TIE-LINE 637 WOOD-TO-STEEL PROJECT
MINOR PROJECT REFINEMENT
REQUEST FORM

Date Requested:	June 3, 2014	Report #:	010
Date Approved:	June 11, 2014	Approval Agency:	No other agency approval is required.
Property Owner(s):	Private and SDG&E Right-of-Way (ROW).	Location/Milepost:	P151, P151(B), and Stringing Site Nos. 20 and 21
Land Use/ Vegetative Cover:	The proposed impact area occurs primarily within non-native grassland surrounded by oak savannah habitat, and bare ground.	Sensitive Resources:	Sensitive habitats including non-native grassland and oak savannah habitat.
Refinement / Modification From (check all that apply):			
<input type="checkbox"/> Permit	<input type="checkbox"/> Plan/Procedure	<input type="checkbox"/> Specification	<input type="checkbox"/> Drawing
<input checked="" type="checkbox"/> Other: Stringing Site Modification, Additional Turnaround Area and Overland Travel Route, Access Road Modification, and Existing Pole Modification.			
<p>San Diego Gas & Electric Company (SDG&E) is proposing to utilize a different temporary workspace for Stringing Site Nos. 20 and 21 (SS-20 and SS-21), located near Structure No. P151, than the workspace area that was originally describ

Figure 1: MPR Overview Map showing the original stringing site locations (SS-20 and SS-21), adjacent pole locations, and the existing Project-approved access road (dashed red lines).

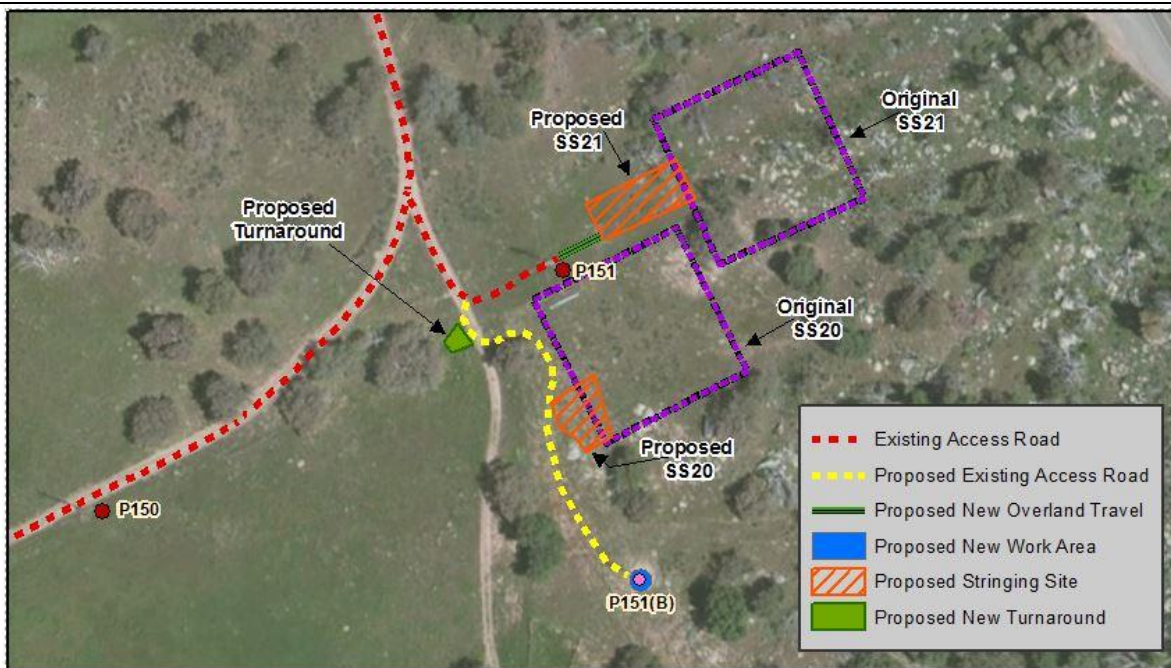
SS-20 and SS-21 were originally planned to be located within two discrete 150 foot by 150 foot areas located entirely within private property adjacent to the existing access road near Structure No. P151 (refer to Figure 1). Structure P151(B) was originally not anticipated to require any work and the proposed new overland travel and turn-around location were similarly not included as part of the Project as originally proposed. The new segment of existing access road to SS-20 and Structure P151(B) is an existing access road that was not identified as being part of the Project as originally proposed.

Following in-field review of the stringing sites, construction crews identified potential logistical concerns with utilizing the originally planned temporary workspace areas for SS-20 and SS-21 (refer to Figure 1). The modified SS-20 and SS-21 temporary workspace areas are advantageous over using the existing SS-20 and SS-21 locations because the areas are more conducive to the proposed work activities and both will result in less anticipated temporary impacts than originally contemplated.
